TOWN OF PARADISE VALLEY

Kachina Estates Subdivision Sign & Modified Subdivision Wall (MI-17-02)

Town Council
Work Session

September 28, 2017

SITE PLAN

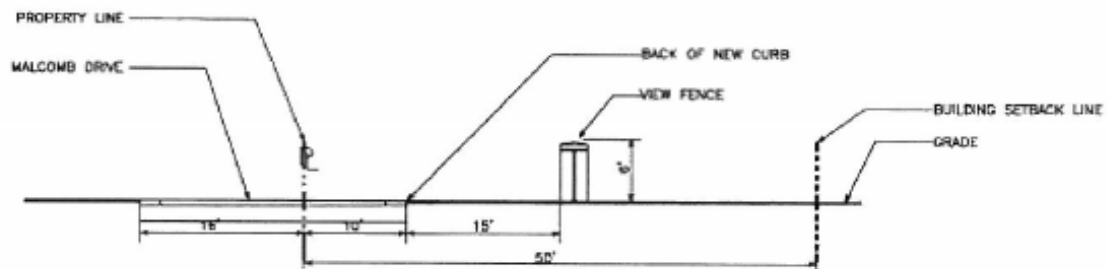
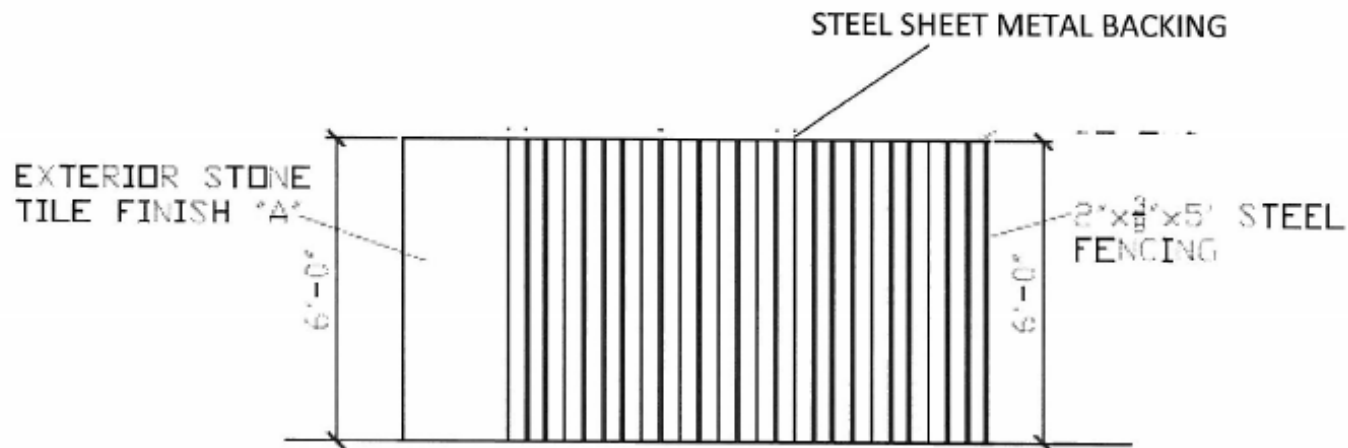
- Staff supportive of sign:
 - Sign not illuminated and only one sign
- Staff not supportive of fence wall screening:
 - Does not meet intent of original Council approval
 - Originally approved with 25' roadway easement (in lieu of ROW dedication)
 - Approved with view fence in order to preserve and maintain visual openness
 - Screening eliminates visual openness and increases presence or massing of fence
